Product Change Notification / JAON-09FELG311

CCB 6066 Final Notice: Implement top marking changes for PD69208T4ILQ-TR-LE, PD81101ILQ-TR-LE, PD69208MILQ-TR-LE, PD69204T4ILQ-TR-LE, and PD39208ILQ-TR-LE catalog part numbers (CPN) available in 56L VQFN (8x8x1.0mm) package.

CCB 6066
Pre and Post Change Summary
PCN # JAON-09FELG311

Marking Change Summary

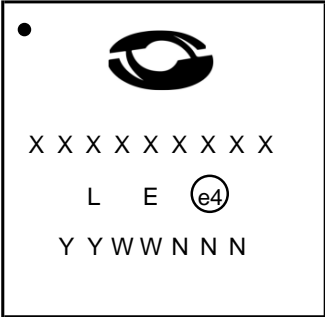
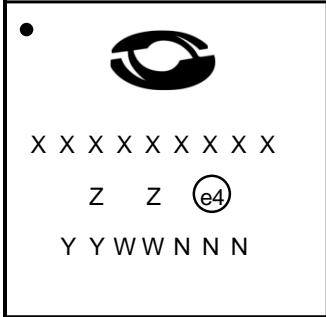
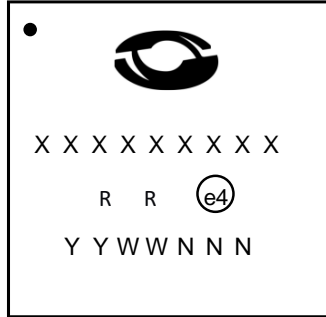
Pre Change	Post Change
Top Mark	Marking Line 3 V2R4: LE V2R5: ZZ	Marking Line 3 V2R4: LE V2R5: ZZ V2R6: RR
	See attached photos for the pre and post changes

Reason for Change:To improve productivity by implementing top marking changes for marking line 3 to specify V2R6 from existing material (V2R4 and V2R5).

V2R4 Mark Line 3: L E	V2R5 Mark Line 3: Z Z	V2R6 Mark Line 3: R R
<p>Pin 1 corner</p>  <p>Diagram showing the marking layout for V2R4. It features a square frame with a dot at the top-left corner labeled "Pin 1 corner". Inside the frame, there is a Microchip logo at the top. Below the logo is a horizontal line of eight 'X' characters. Underneath that is the text "L E" followed by a circled "e4" symbol. At the bottom is a horizontal line of eight characters: "Y Y W W N N N".</p>	<p>Pin 1 corner</p>  <p>Diagram showing the marking layout for V2R5. It features a square frame with a dot at the top-left corner labeled "Pin 1 corner". Inside the frame, there is a Microchip logo at the top. Below the logo is a horizontal line of eight 'X' characters. Underneath that is the text "Z Z" followed by a circled "e4" symbol. At the bottom is a horizontal line of eight characters: "Y Y W W N N N".</p>	<p>Pin 1 corner</p>  <p>Diagram showing the marking layout for V2R6. It features a square frame with a dot at the top-left corner labeled "Pin 1 corner". Inside the frame, there is a Microchip logo at the top. Below the logo is a horizontal line of eight 'X' characters. Underneath that is the text "R R" followed by a circled "e4" symbol. At the bottom is a horizontal line of eight characters: "Y Y W W N N N".</p>
